Hands Free and Master Instrument Panel Software Update
Models: Diavel (all country versions, all models EXCEPT Diavel Strada) M.Y. 11-12-13
Service Bulletin SVC-13-013

Date: Tuesday, April 23, 2013
To: Dealer Principal, General Manager, Service Manager, North American Dealer Network
From: Austin Gray, Technical Director; Antonio Munoz, Service Business Manager;

DESCRIPTION OF NEW HANDS FREE OPERATING STRATEGY AFTER UPDATE TO “VERSION 50”

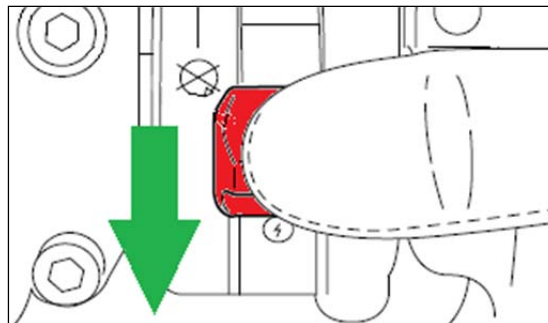
The new “version 50” software of the Hands Free control unit no longer takes into account the information from the steering limit switch, operated by the claws, to turn on the steering lock.

The new operating logic of the steering lock no longer detects the steering limit stop position and the **“WAITING FOR LOCK”** message is no longer activated. It is the rider's responsibility to make sure that positioning is correct.

Note that if the steering is not positioned correctly, the steering lock will not turn on and you may hear a noise from the Hands Free unit.

For correct use, turn the steering into the correct position (fully right or fully left) within 60 seconds from turning off the instrument panel, and hold the “RUN” button depressed for 3 seconds while keeping the steering fully turned left or right.
